## RESIDENTIAL DEVELOPMENT

# 8 Forest Road | Warriewood NSW 2102

SECTION 4.56(4) APPLICATION

#### SECTION 4.56 CHANGE LIST ADDENDUM (07/05/2024) (REFER TO CHANGE SCHEDULE FOR MORE DETAILS)

Roof Level - East

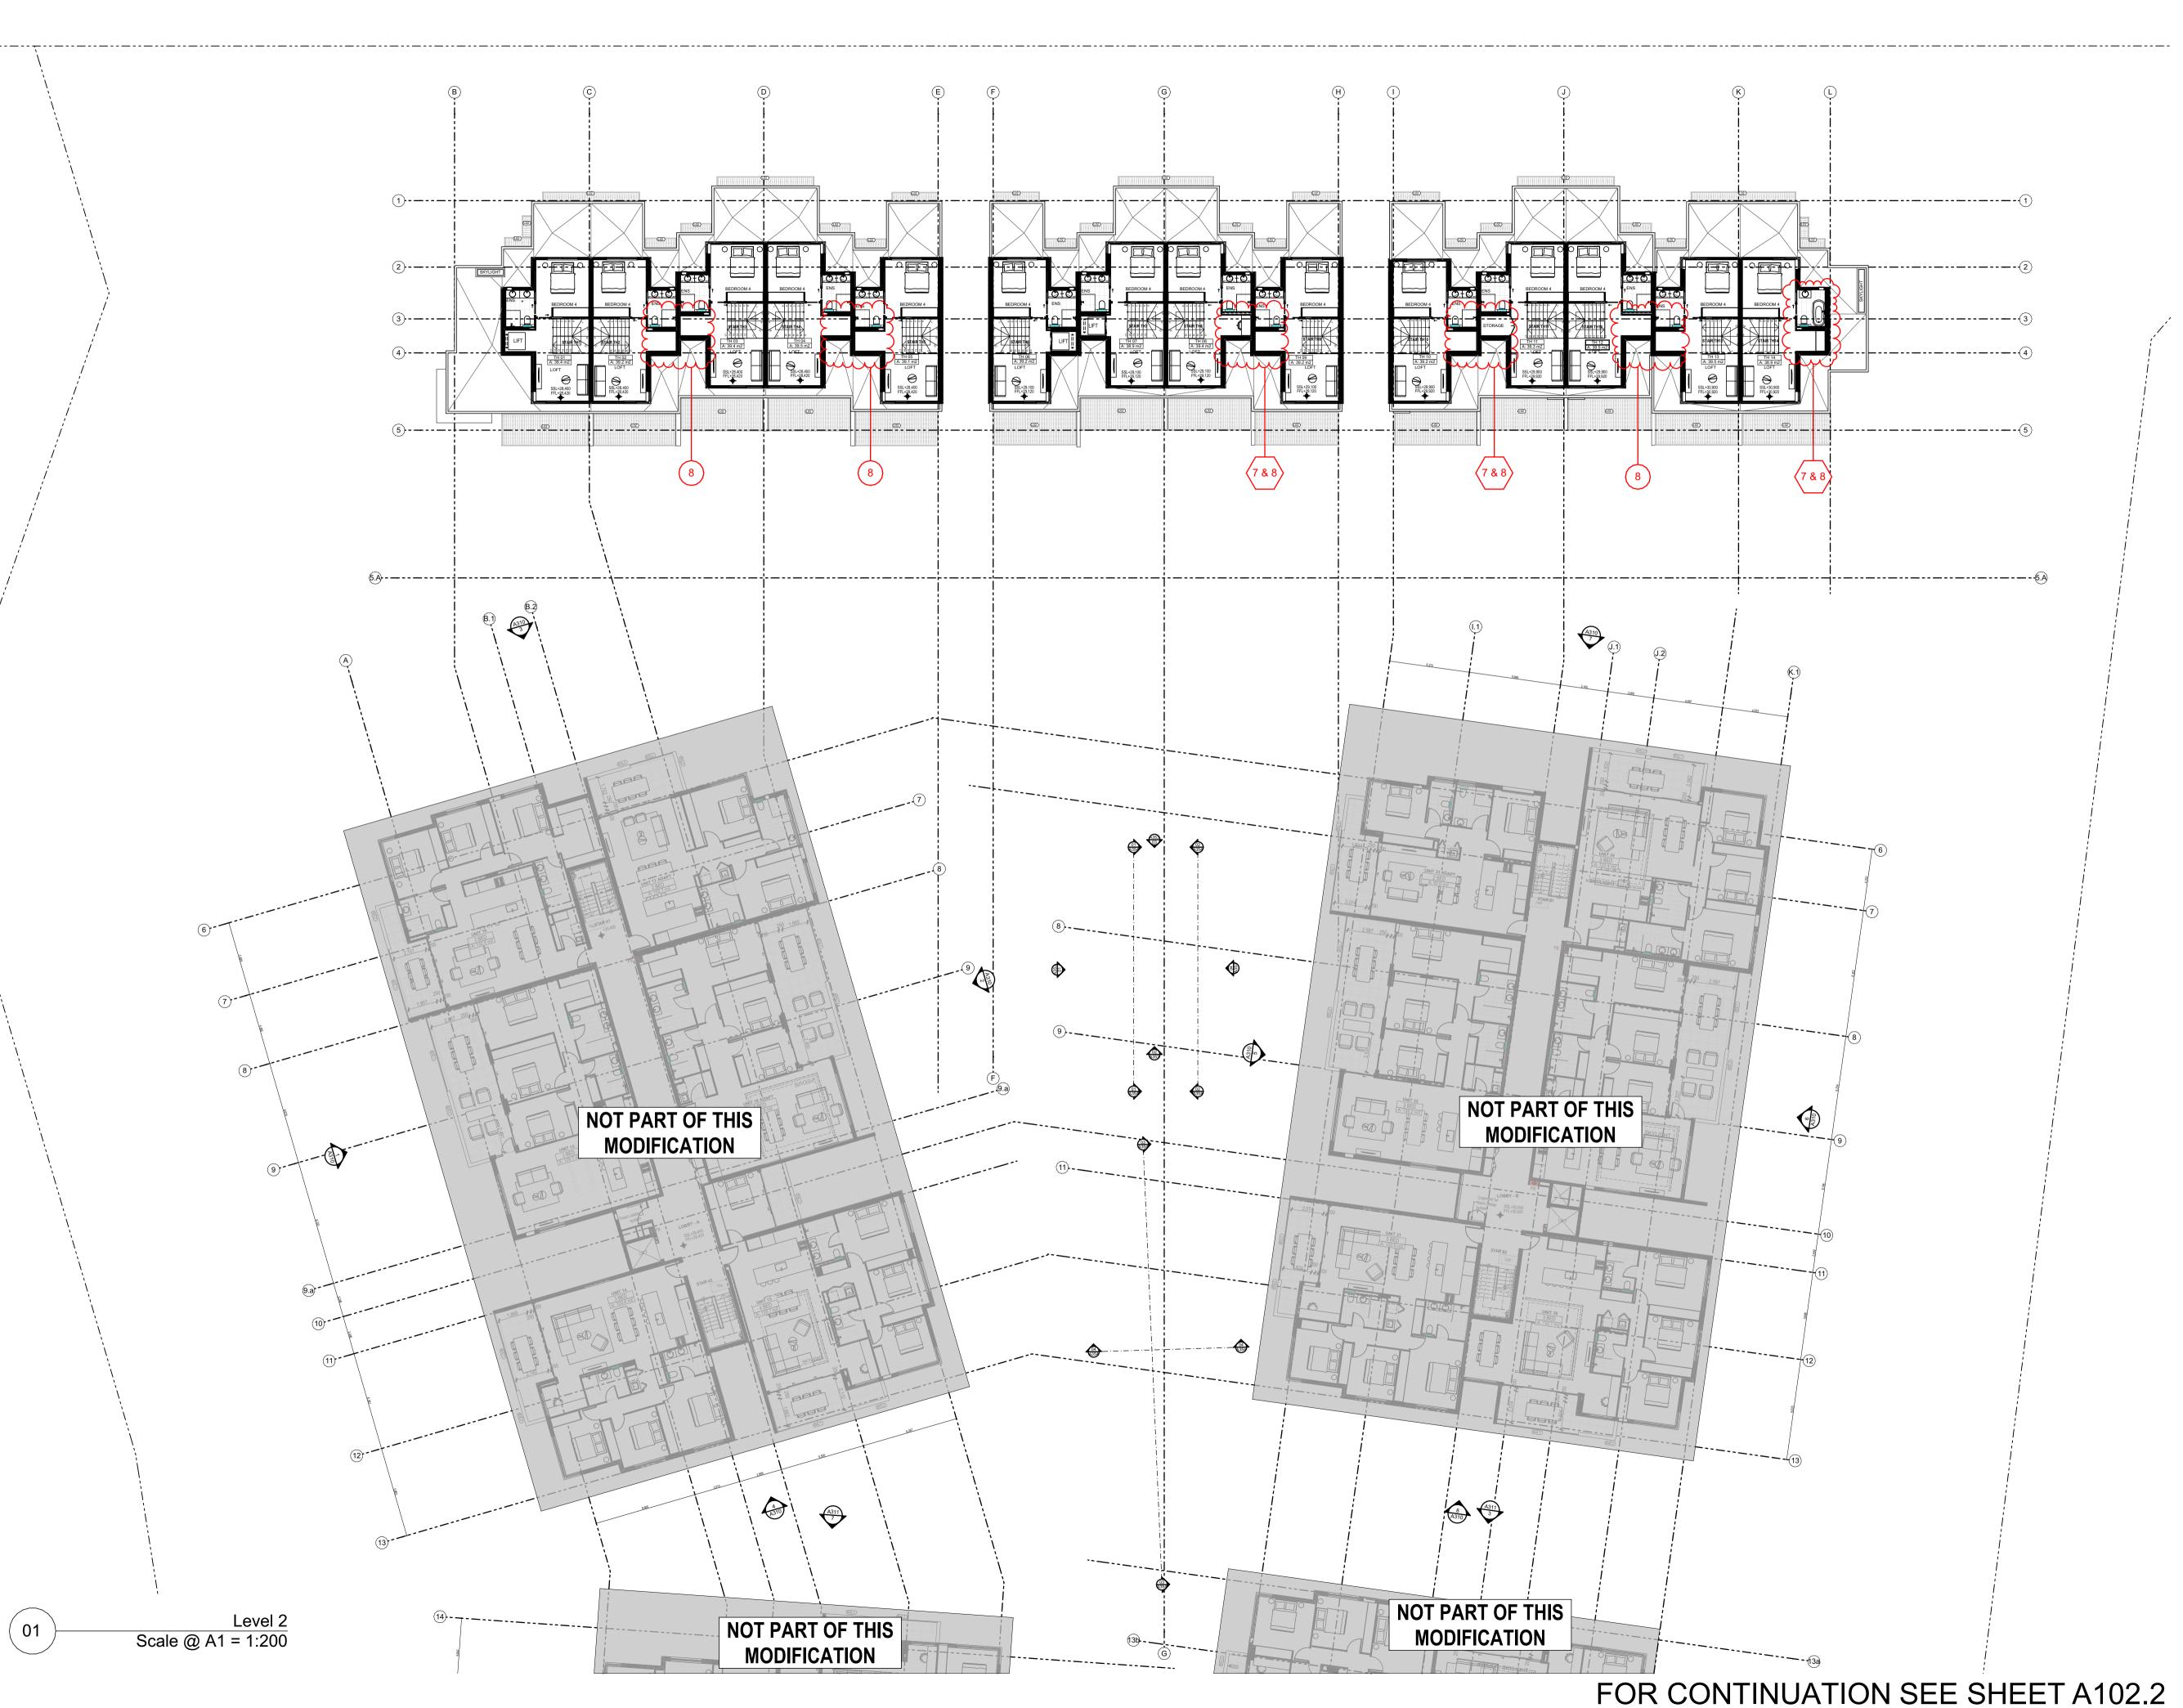
1. LIFT OVERRUN REMOVED & ALLOWANCE FOR ROOF PARAPET ADDED, THE HEIGHT OF WHICH IS 100mm LOWER

THAN THE PREVIOUSLY APPROVED LIFT OVERRUN HEIGHT. 12. INTERNAL FITOUT CHANGES TO UNIT 12 TO COMPLY WITH NDIS REQUIREMENTS

Drawing Title: Elevations Building C and D

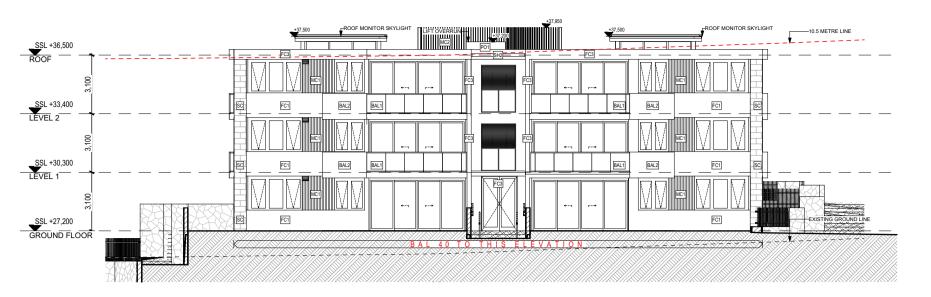
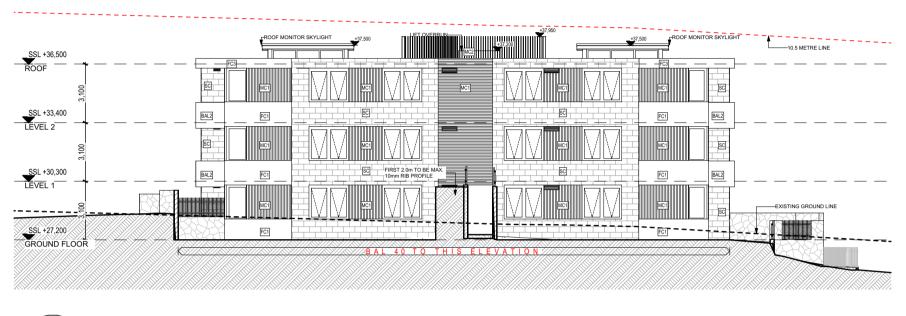
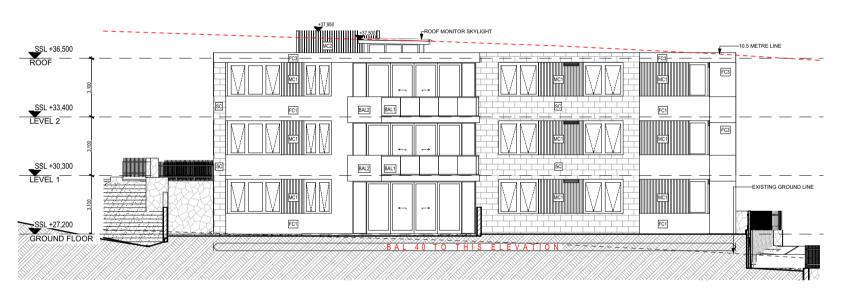
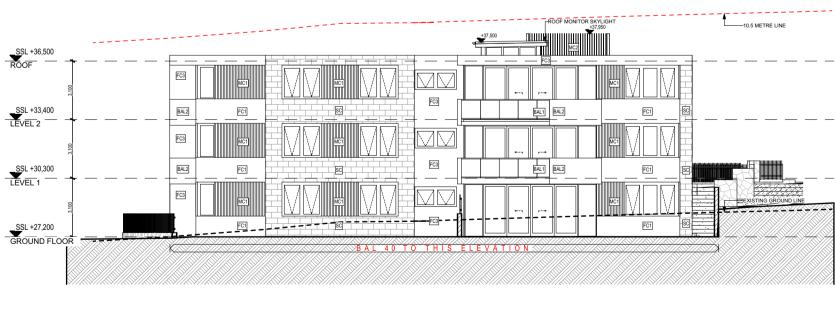
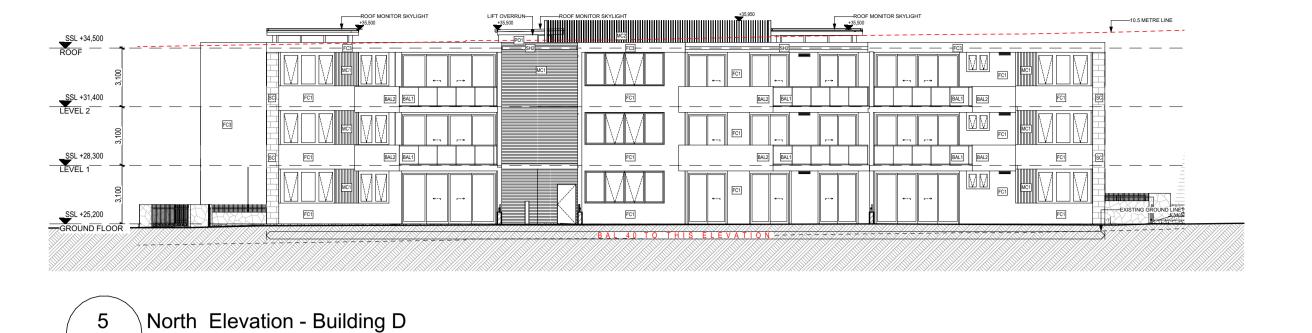
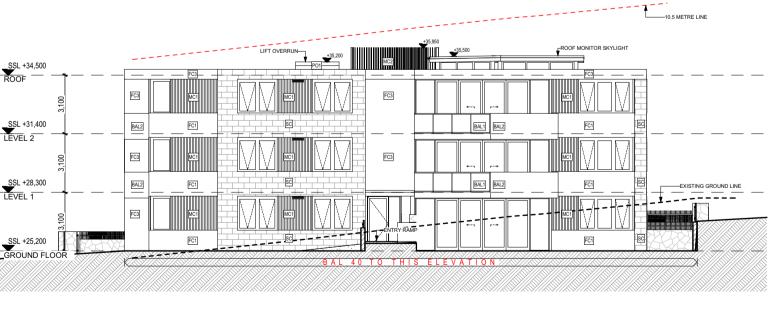
FINISH CHANGES, "TIMBER LOOK" CHANGED TO "DULUX

DURALLOY ANOTEC MID BRONZE MATT" AND "SANDSTONE

PARAPET ADDED, THE HEIGHT OF WHICH IS 100mm LOWER THAN THE PREVIOUSLY APPROVED LIFT OVERRUN HEIGHT.
